Summit County Planning Commission (SCPC) Thursday, November 21, 2024 - 3:00 p.m. County of Summit, County Council Chambers 175 South Main Street, 7th Floor, Akron, Ohio **Meeting Agenda**

Planning Commission Final Plat **Picton Parkway** Springfield Township

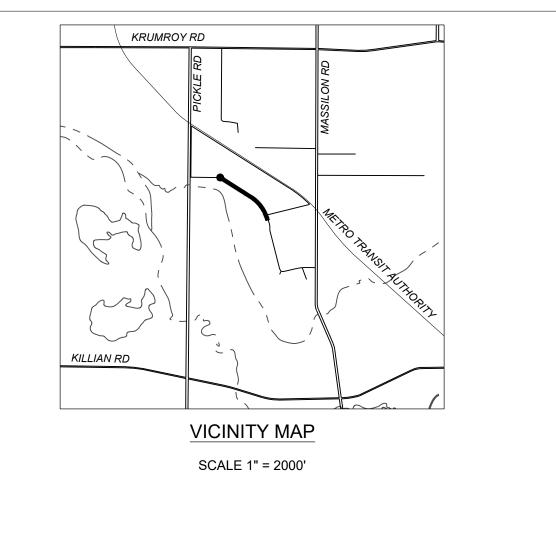
- Title remove reference to "being a replat of Block 2-BR....."
- Describe "found" monumentation
- Add signature block for Summit County Planning

Planning Commission Zoning Map Amendment Dangel Ave Springfield Township

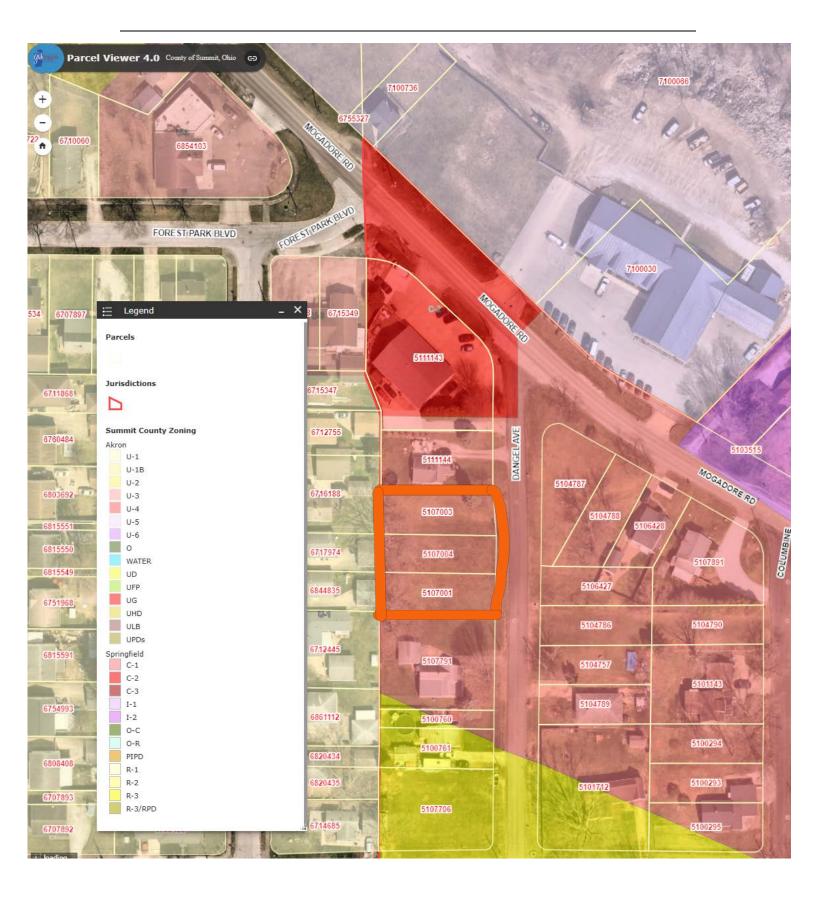
- The site can be used as currently zoned.
- There are adjacent residential use parcels.
- The proposed Map Amendment is not consistent with the future land use plan.
- Current zoning districts don't follow parcel lines
- Commercially zoned properties along Mogadore Rd makes sense
- These parcels are not adjacent to Mogadore Rd.
- Other properties on Dangle should be asked to join rezoning to connect zoning to R-3 zoning to the South.
